STATE OF NORTH CAROLINA
DEPARTMENT OF TRANSPORTATION

September 10, 2007

SUBJECT: Permit Modification Request for TIP No. R-2809A, Wake Forest Bypass,
From west of Thompson Mill Road to east of Jones Dairy Road, Wake
County, Federal Aid No. HPSTP-55 (12), State Project No. 8.1402501:

Permit Drawing
Sheet 13 of 19

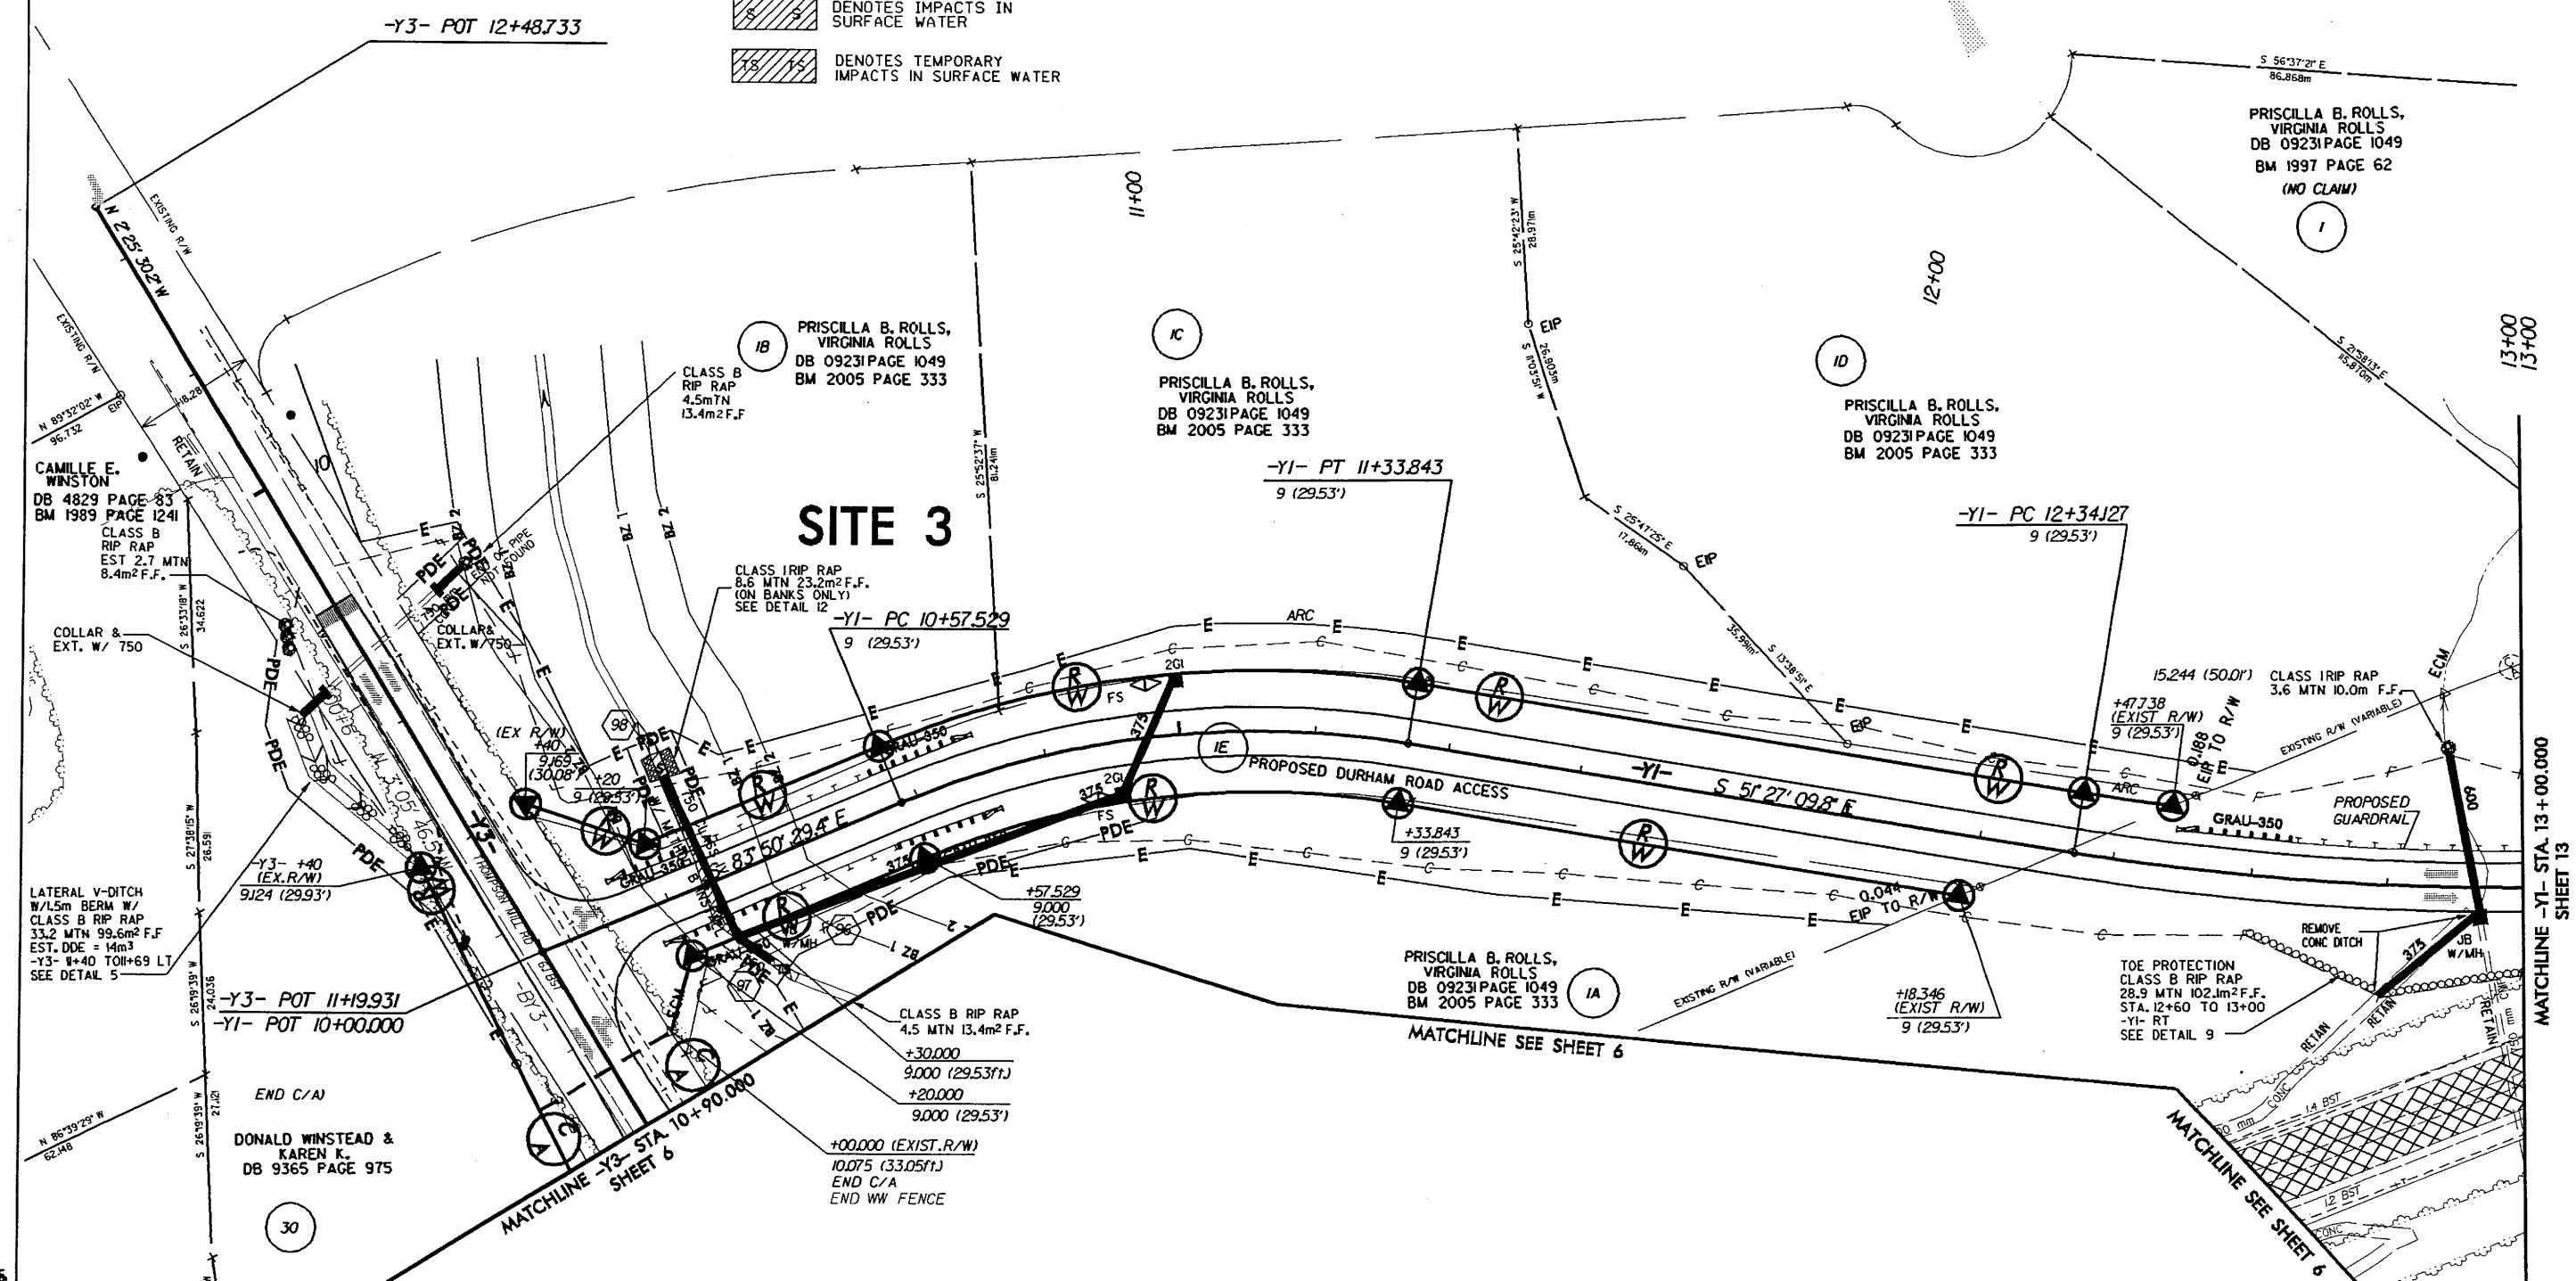
A new 30-inch CSP will be placed in UT2 to allow for the construction of a proposed access road. The crossing of UT2 at Site 3 is located approximately 120 feet to the north (downstream) of Site 2. Construction of the 30-inch pipe and the associated work will result in 118 feet of permanent stream impacts and 36 feet of temporary stream impacts in UT2. Impacts to UT2 were not originally permitted in the original permit because the stream was not identified during the original delineation and verification. No mitigation is proposed at this site because the stream was determined to be intermittent and no signs of aquatic life were found during the onsite verification with Brian Wrenn of the DWQ on October 15, 2004. Eric Alsmeyer of the USACE deferred to the DWQ.

**Impact change: increase of 118 feet of permanent impacts to UT2 to Horse Branch
increase of 36 feet of temporary impacts to UT2 to Horse Branch**
